# Helpful Hints **0028**

REVISION: 02

**SUBJECT:** Installation of the Multi-Layer Control Board

**MODELS:** Merlin IV, Merlin 20+, Milk Merchandiser, EZ Vender

Service Mode Button

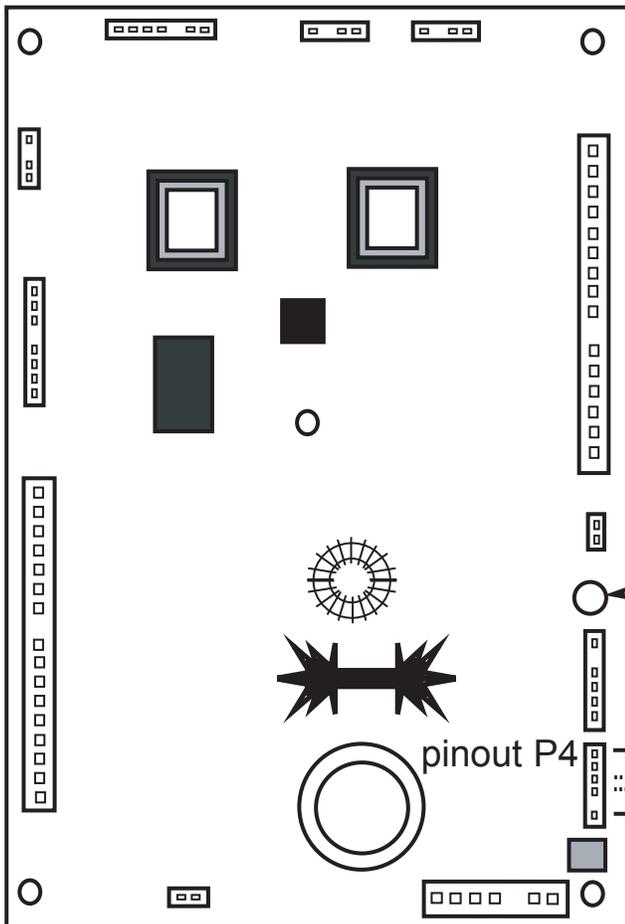
**REASON FOR HINT:** Beginning in mid-December 2001, all new Merlin venders have a Multi-Layer Control Board, instead of the older single-layer board. The design of this new board provides better protection against electromagnetic noise, which could corrupt the control board.

**How to distinguish the Multi-Layer board from the older Merlin board:** Look on the control board for a six-digit part number, beginning with "4." On the older Merlin board, this number will be 407862, and it will be located on the back of the board. On the Multi-Layer board, this number will be 408266, and it will be located on the front of the board, near the Service Mode Button.

1. Remove power from vender by unplugging the vender's main power cord from the AC voltage power source.
2. Disconnect all harnessing to the existing control board, and remove the board from the vender.
3. Mount the new Multi-Layer Control Board in the vender.
4. Reconnect all harnesses to the board. **Note:** In the Merlin 20+ vender, it will be necessary to replace the older optic interface-to-board harness with a newer harness (p/n 842266). This new harness will connect at pinout P4 on the control board.
5. Restore power to the vender by plugging the vender's main power cord into the AC voltage power source.
